PUBLIC SERVICE COMPANY)
OF NEW HAMPSHIRE, ET. AL)
(Seabrook Station, Units 1 & 2)

COMMENTS

Prof. Mihailo D. Trifunac

March 20, 1981

Figure 1

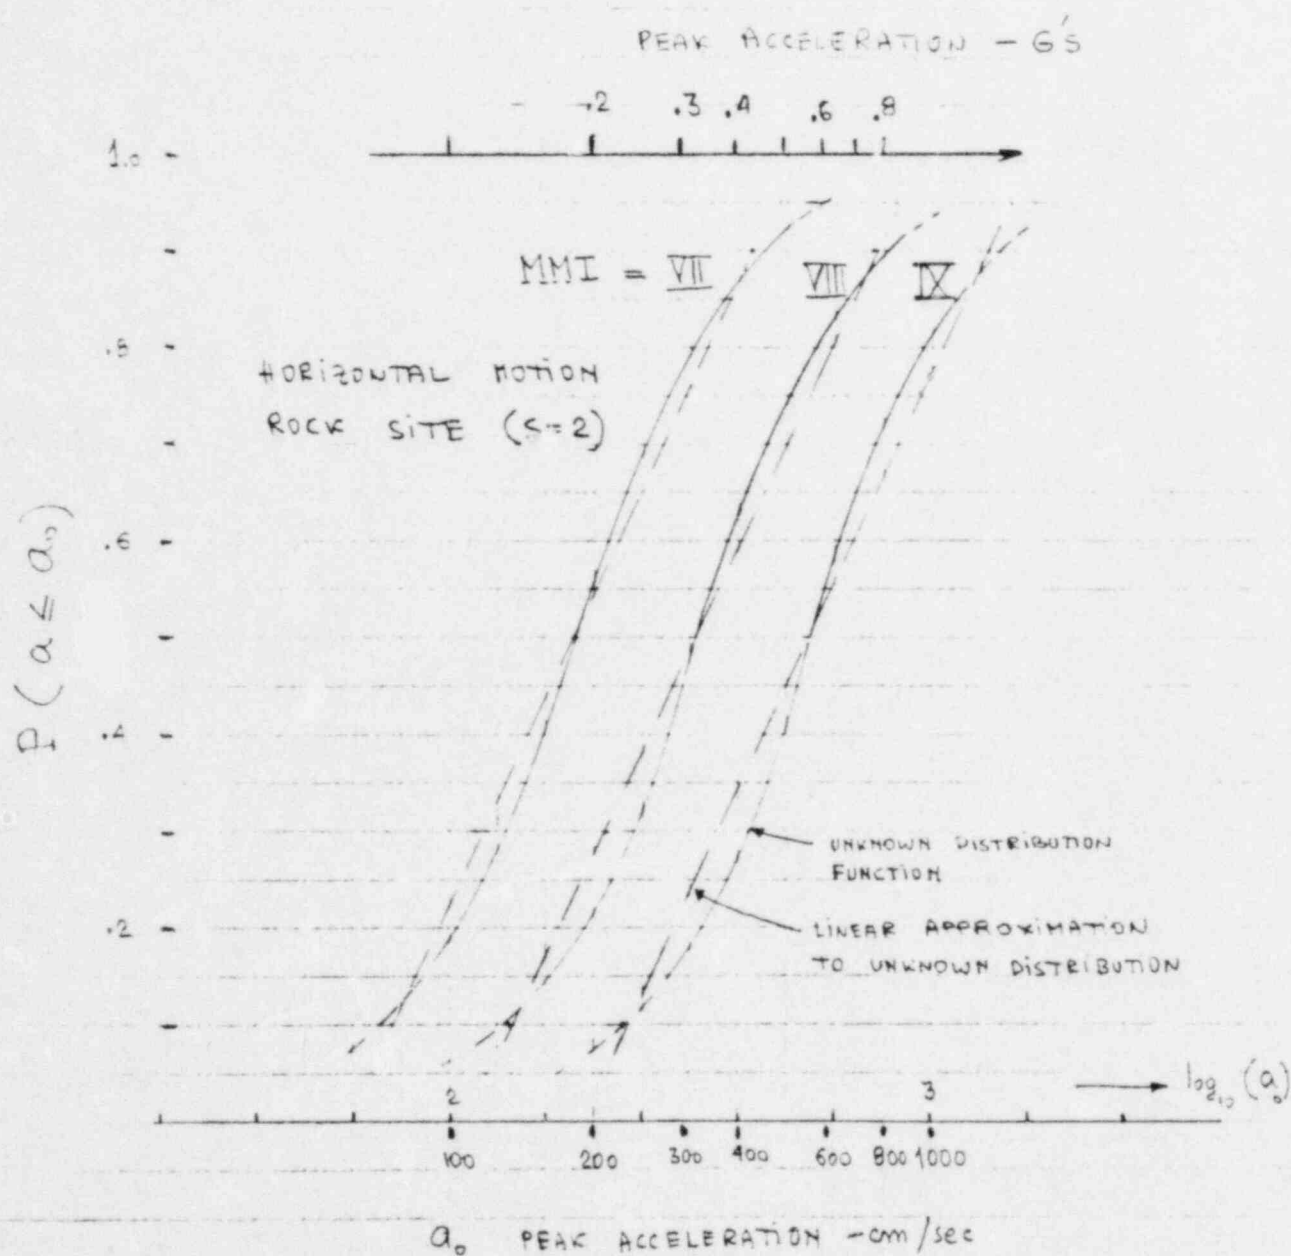
of shaking to an amplitude of peak ground acceleration. Here one finds a considerable spread of the recorded peak acceleration for the same site intensity, shown in Figure 1. This figure illustrates how the distributions of peaks $P(a \leq a_0)$ might look like. The dashed straight lines, approximating this unknown distribution, have been plotted here by using the Table VI in Trifunac (1976). It is seen, for example, that the 80% confidence interval for recorded peak accelerations for the site intensity $MMI=VIII$ is from $\sim 0.15g$ to $\sim 0.70g$. The point to be noted here is that when a peak acceleration is presented it must be viewed with this wide distribution in mind.

In Figure 1 and elsewhere in this discussion "peak acceleration" will mean the largest absolute amplitude of acceleration function versus time recorded during the complete strong earthquake motion. For linear response analysis using response superposition technique this is the only correct use of peak acceleration, since the computed response spectra asymptotically approach this peak value as the period of the single degree of freedom oscillator approaches zero. I believe that the term "effective peak acceleration" should not be considered at all, since, so far, no one has precisely defined what is meant by this expression. From the past experience, I found that it is usually smaller than the recorded acceleration, that its interpretation varies from one experts to the next, and that it somehow reconciles the past analyses with recent or new recorded data. From several cases of its usage that I have seen it appears that it avoids the physical basis of the problem and allows unwarranted freedom for expert judgement.

Figure 2

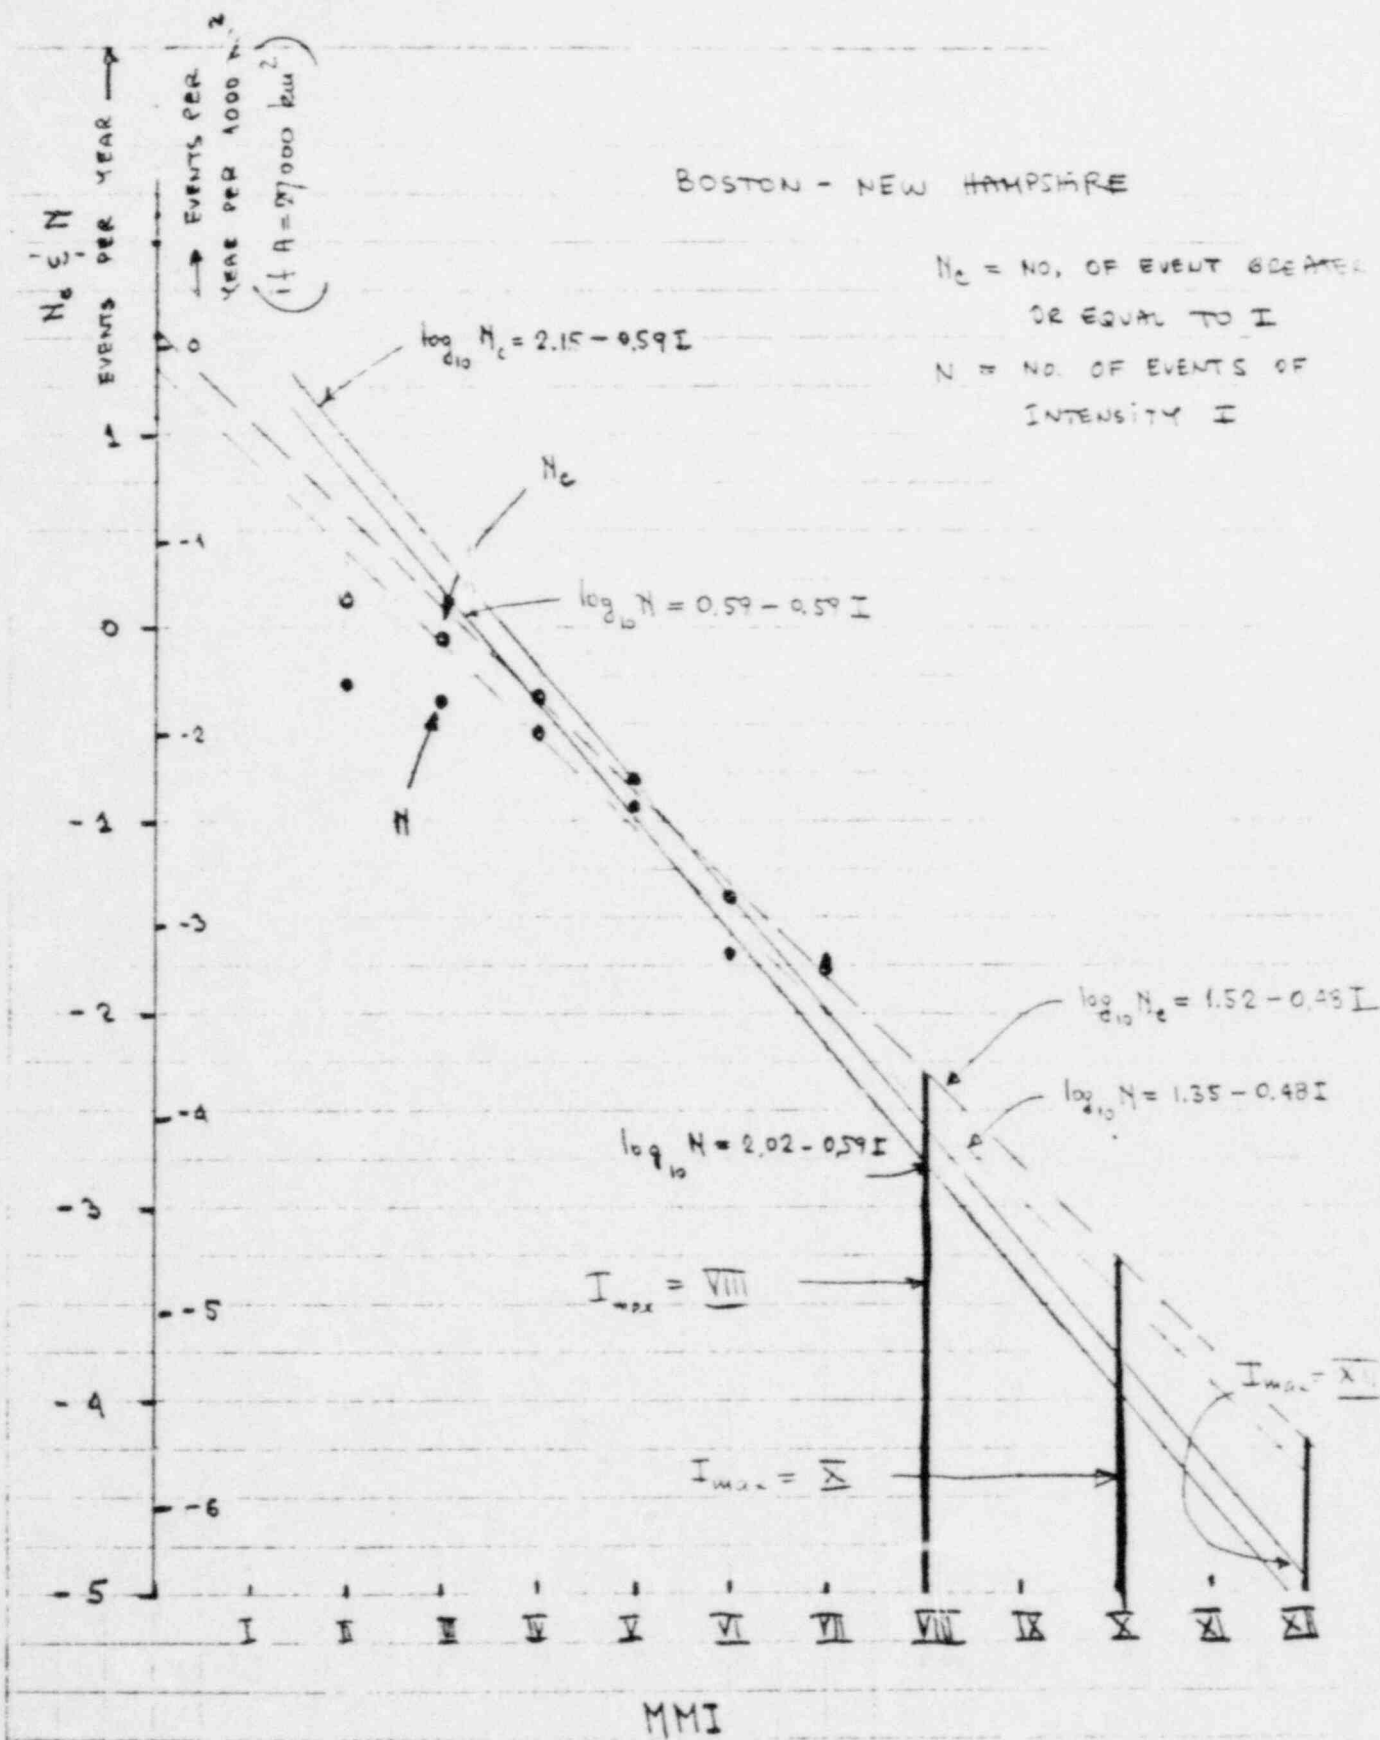
Figure 2 presents the data on the expected number of earthquakes (per year) with different epicentral intensities I on MMI scale, in the area of about 27000 km^2 identified as Boston-New Hampshire region (Chinnery, 1979). The outside (left) scale on the vertical axis gives the logarithm of the number of earthquakes per year for the entire region of 27000 km^2 . The right (inside) scale on the y-axis gives the logarithm of the number of earthquakes per year per 1000 km^2 assuming the total area of 27000 km^2 . Open circles represent N_c (number of earthquakes greater than and equal to I). The full circles represent N the number of earthquakes of intensity which corresponds to the x-coordinate of the point.

Figure 3

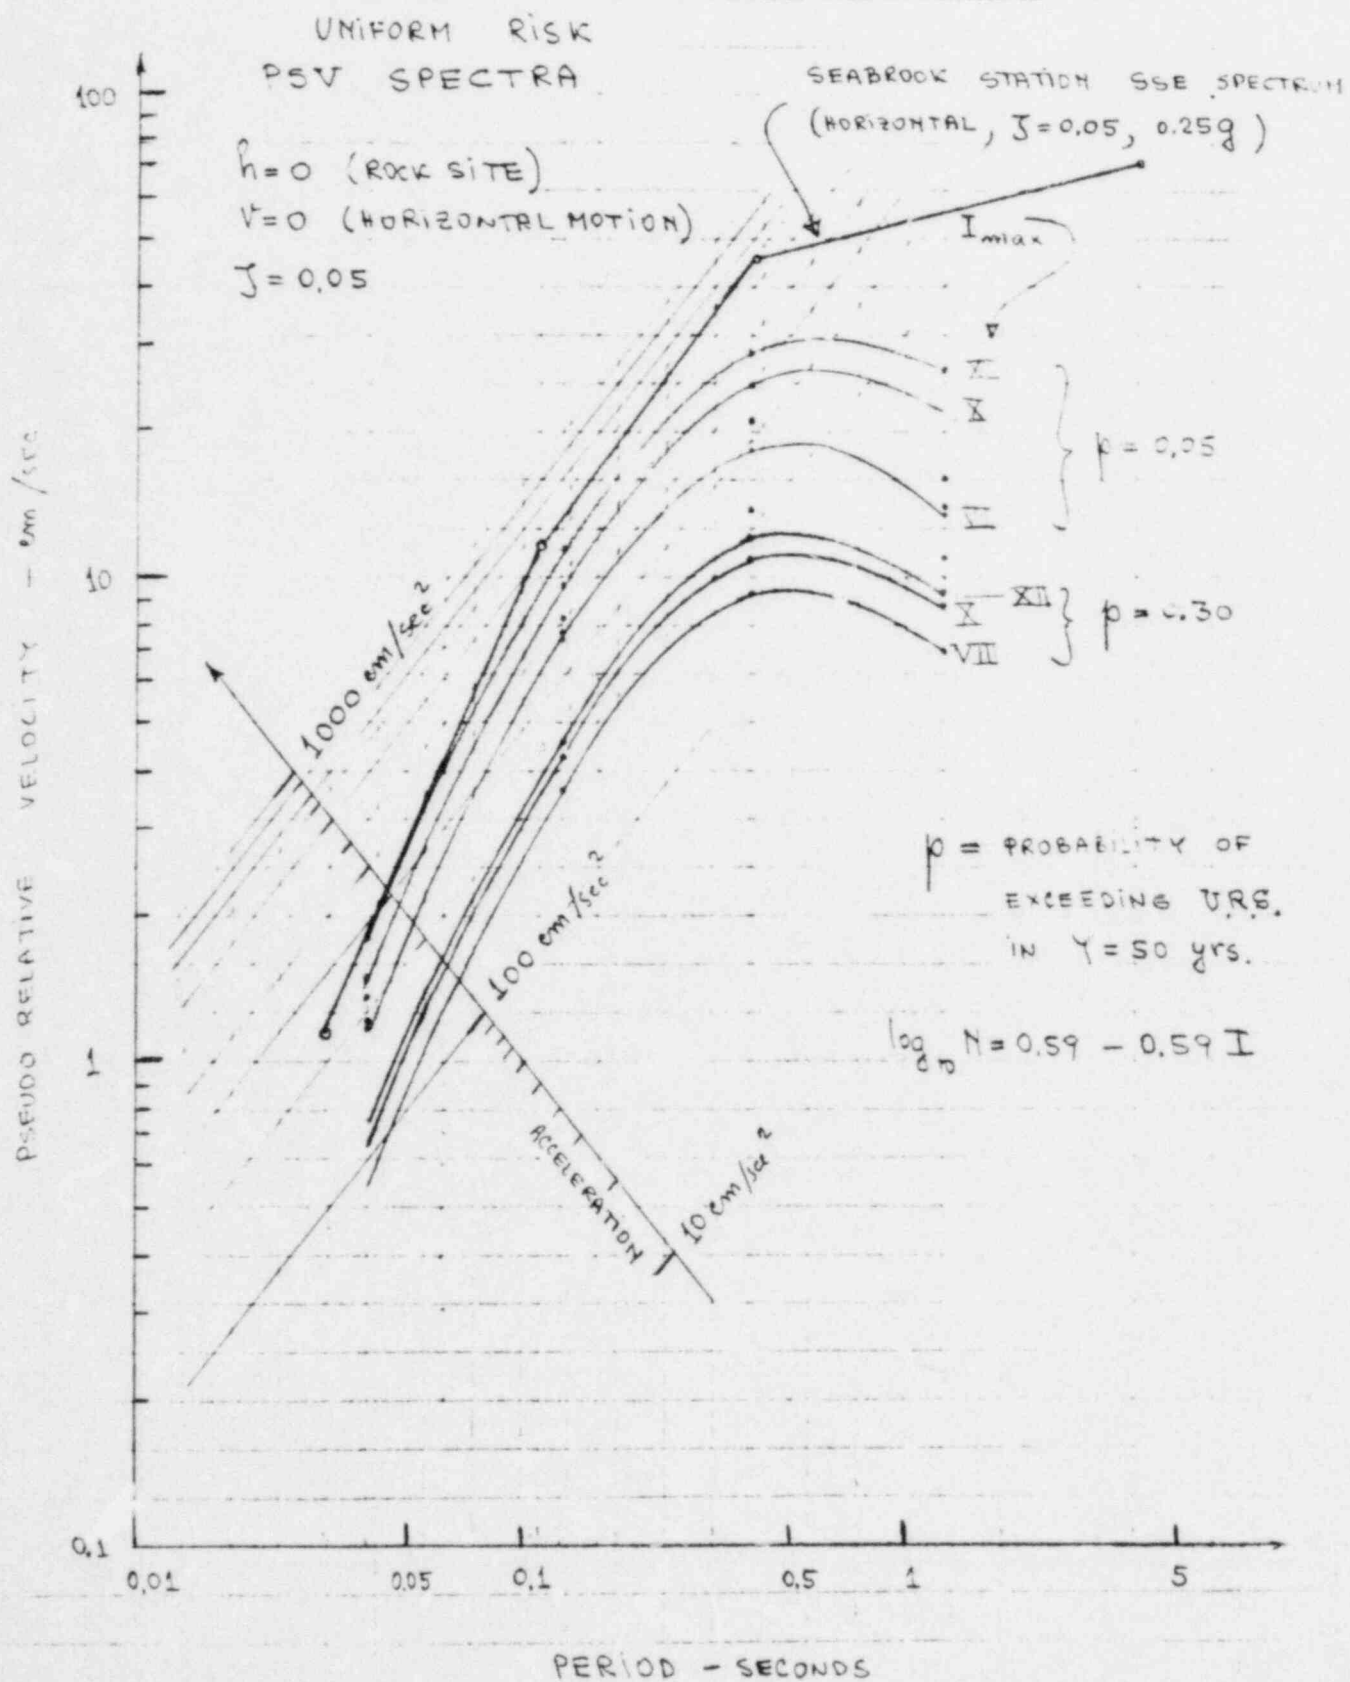
Figures 3 and 4 summarize the results of computed URS of Pseudo Relative Velocity (PSV) at a rock site ($h=0$ km, where h represents the depth of sediments beneath the site), for horizontal ground motion and for structural damping of $\zeta = 0.05$. Each figure shows two groups (each consisting of three URS spectra) of curves for $p=0.05$ and $p=0.30$. Here p represents the probability that these spectra will be exceeded at least once during the next 50 years. Each group contains three URS curves corresponding to the three cases analyzed and for the maximum intensity in the area assumed to be VIII, X or XII. Both figures also show the SSE spectra proposed for the Seabrook site and corresponding to 0.25g peak acceleration and $\zeta = 0.05$.

Figure 3 shows that these calculations suggest the probability of exceeding the proposed Seabrook design spectra during the next 50 years is less than 0.05, assuming no limit on the maximum epicentral intensity in the region. Assuming that the largest possible intensities are X and then VIII the probability of exceeding the SSE spectra for Seabrook is further reduced. This also means that for the seismicity represented by the model in equation (3), during the next 50 years the probability that the peak acceleration equal to 0.25g will be exceeded is less than ($I_{\max} = \text{VIII and X}$) or equal to 0.05 (if $I_{\max} = \text{XII}$).

Figure 4

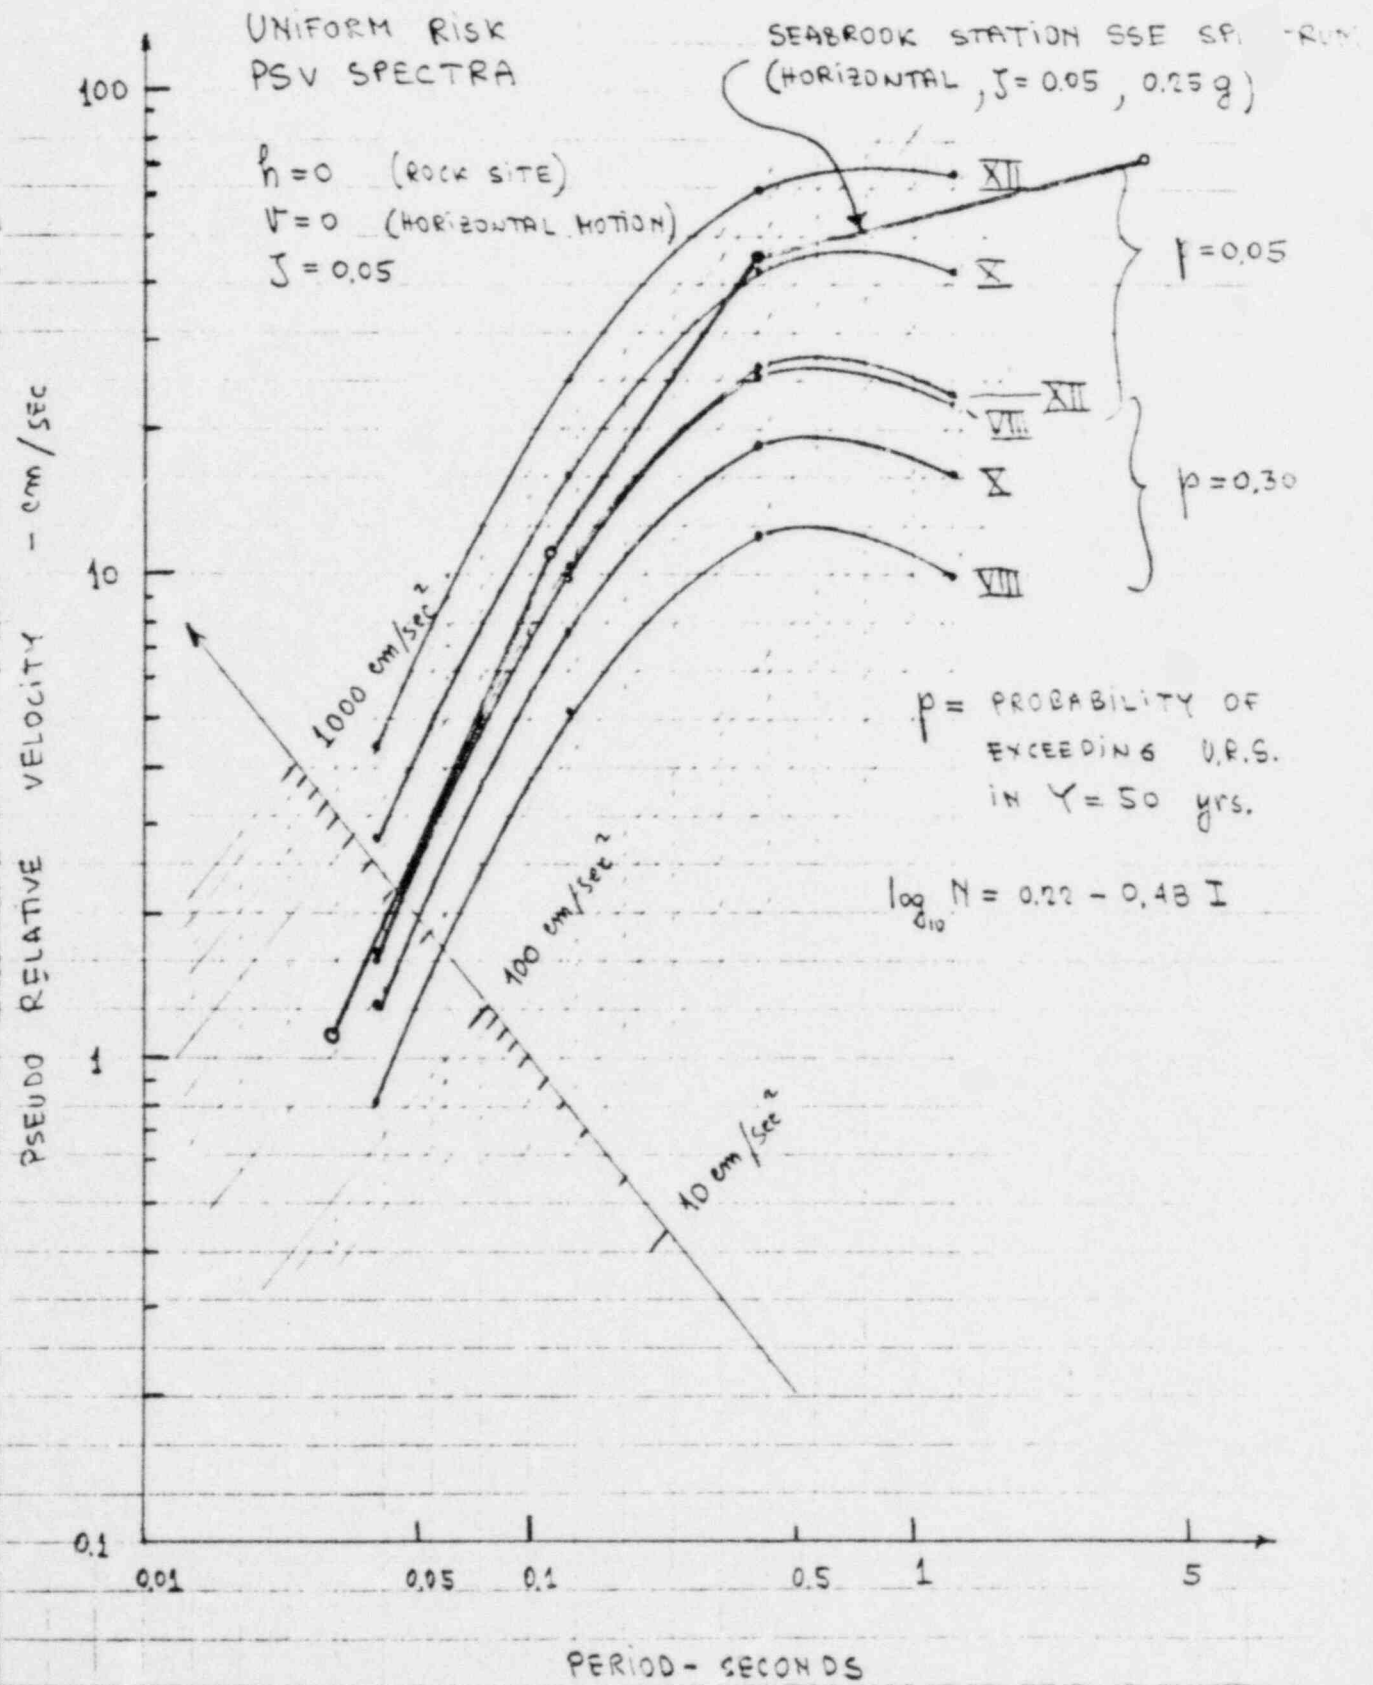
Results in Figure 4 show that if the site seismicity is equal to

that described by equation (4) that the probabilities of exceeding the proposed SSE spectra at Seabrook Site are as follows:

Maximum area intensity	Probability of exceeding Seabrook Spectra
$I_{\max} = \text{VIII}$	< 0.05
$I_{\max} = \text{X}$	< 0.15
$I_{\max} = \text{XII}$	< 0.30
